Certificate of Appropriateness Application (Deferred from November 28, 2006)
BAR 06-06-02
1401 Gordon Avenue
TM 5 P 83
Brad Booker and Laurie Veliky, Applicants
Construct 4 bedroom detached unit to rear of existing structure

**CITY OF CHARLOTTESVILLE
BOARD OF ARCHITECTURAL REVIEW
STAFF REPORT
March 20, 2007**

**Certificate of Appropriateness Application (deferred from November 28, 2006)
BAR 06-06-02
1401 Gordon Avenue
TM 5 P 83
Brad and Laurie Booker, Applicant
Construct 4 bedroom detached unit to rear of existing structure**

A-1

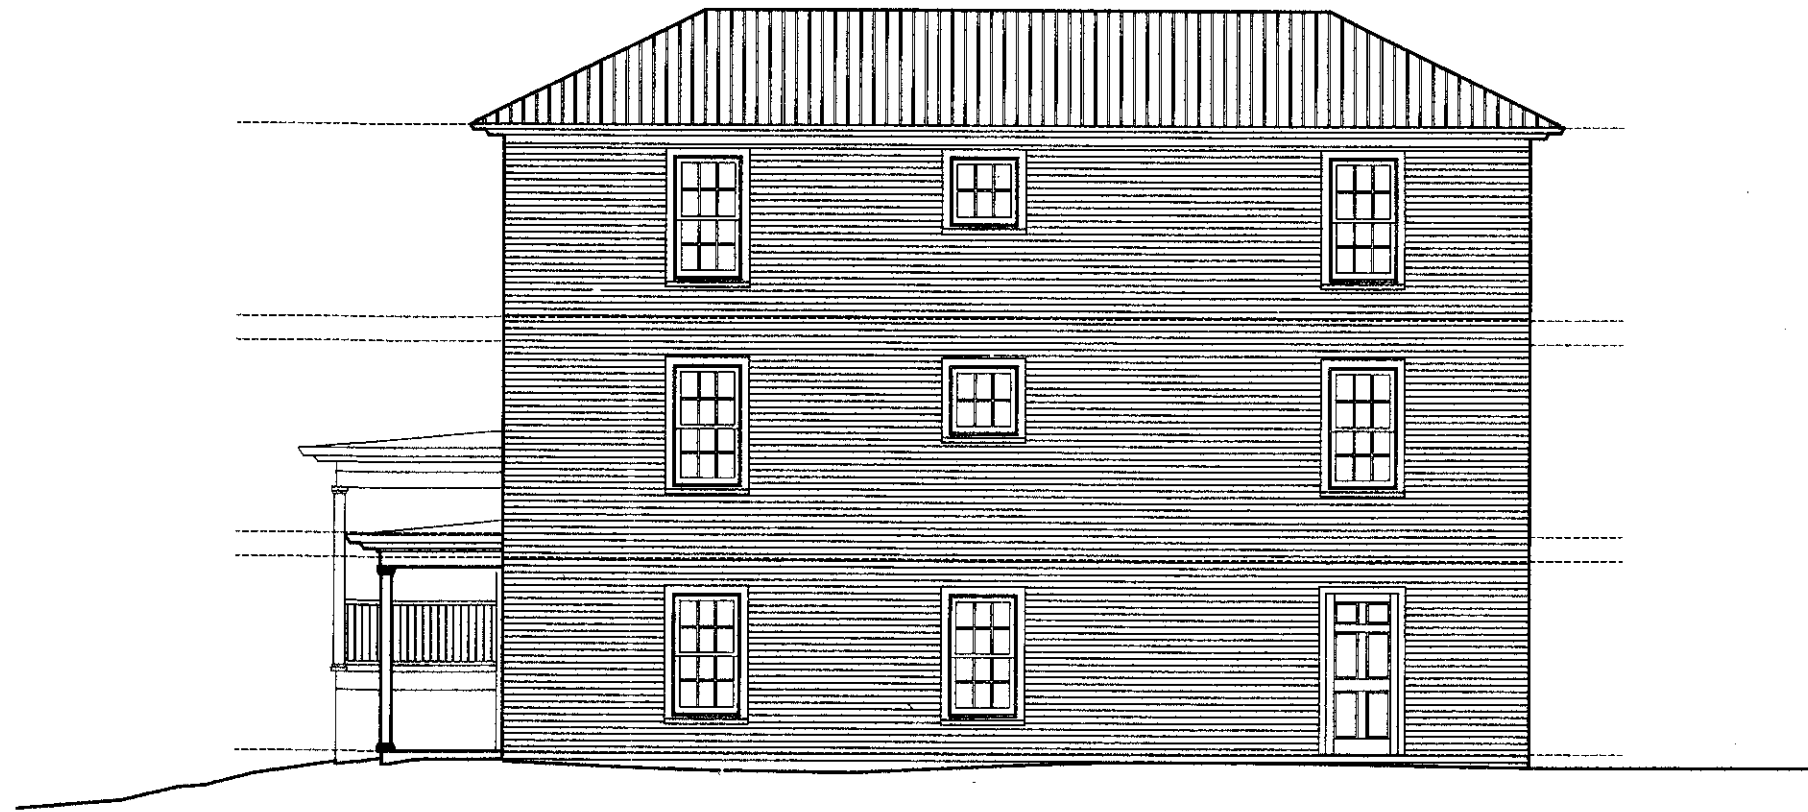
The BAR approved (8-0) version A-1 through A-7 (no dormers) as submitted, except the entrance walkway to the addition must extend to the City sidewalk, and the landscape plan must be modified as described, and submitted for staff approval: Remove some of the shrubs (at the existing porch and at the gap between buildings); keep the Crepe Myrtle at the driveway but add two shade trees in place of the other Crepe myrtle and the Fringetree.

If the BAR wants a sidewalk from the front door to the City sidewalk, then steps will be required to meet the grade. ✓

Please submit your revised landscape plan including the walkway extension.
